Access Compliance Report Public Rights-of-Way (Curb Ramps)

Intersection ID: 10036687 Main Street: S CHURCH ST Cross Street: N/A Location: S Initial Pass/Fail: Pass **Overall Compliance: No Severity Score:** 0 **ADA ID: 78BDB94BE9E7** Ramp Type: BlendTrans1

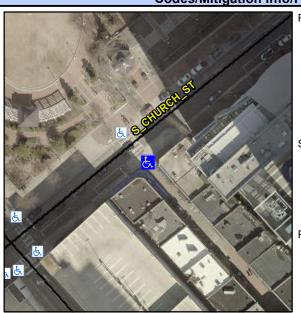
Possible Solutions: Compliance Description N/A Utility Present. Yes N/A Yes N/A Yes Surveyor Notes: Yes N/A Yes Yes N/A N/A PROW/ADA: Yes R302.3, R402.2
